Department of Energy
Washington, D.C. 20545
Docket No. 50-537
HQ:S:82:115

RESPONSES TO REQUEST FOR ADDITIONAL INFORMATION

Reference: Letter, P. S. Check to J. R. Longenecker, "CRBRP
Request for Additional Information," dated April 9, 1982

Question CS421.36

Figure 7.5-7 Liquid Metal/Gas Leak Detection System
Response Time Vs. Sodium Aerosol Concentration (Inerted Cells)

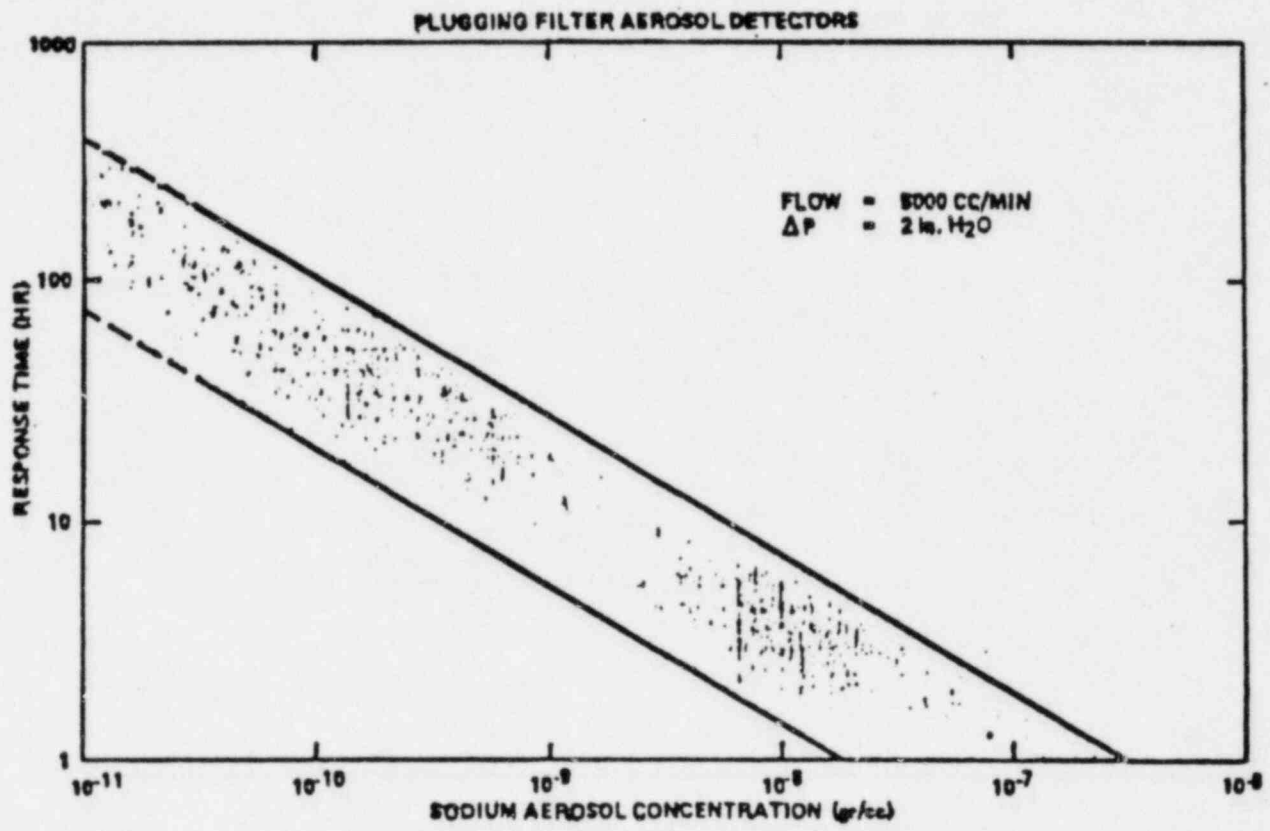
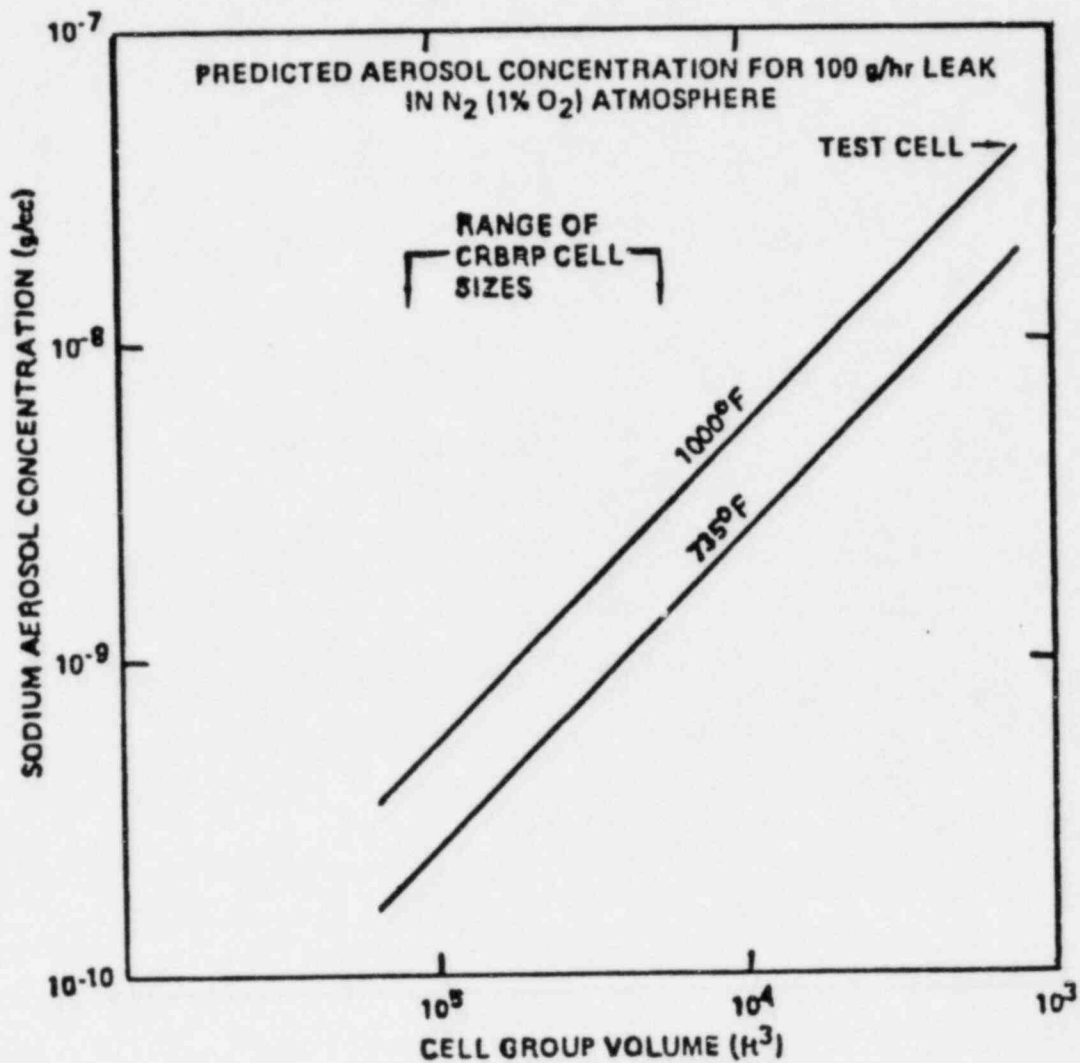
Provide a more detailed discussion of the CRBR Leak Detection system and how it meets the provisions contained in the Light Water Reactor Regulatory Guide 1.45. The discussion should include detection methods, detector sensitivity, detector response time, signal correlations and calibration, seismic qualification, testability, and the provisions for technical specifications.

PSAR Section 7.5.5.1.1 has been revised to provide a more detailed discussion of the CRBRP Leak Detection Instrumentation System. A comparison to the provisions of Regulatory Guide 1.45 is contained in Section 5.3 of WARD-D-185, "Integrity of the Primary and Intermediate Heat Transport System Piping in Containment", (Reference 2 of PSAR, Section 1.6).

Considerations which materially affect detection times include: sodium leak rate, sodium temperature, and cell size. Test data (See Reference 5) confirm that sodium leaks of 100 gm per hour in an air or inert atmosphere can be detected by aerosol detection over the operating temperature ranges, within the detection time periods identified in Figure 5.1.1 of WARD-D-0185, "Integrity of Primary and Intermediate Heat Transport System Piping in Containment", (Reference 2, PSAR Section 1.6). Larger leaks (on the order of kg/min) will be readily detected by two or more systems in minutes.
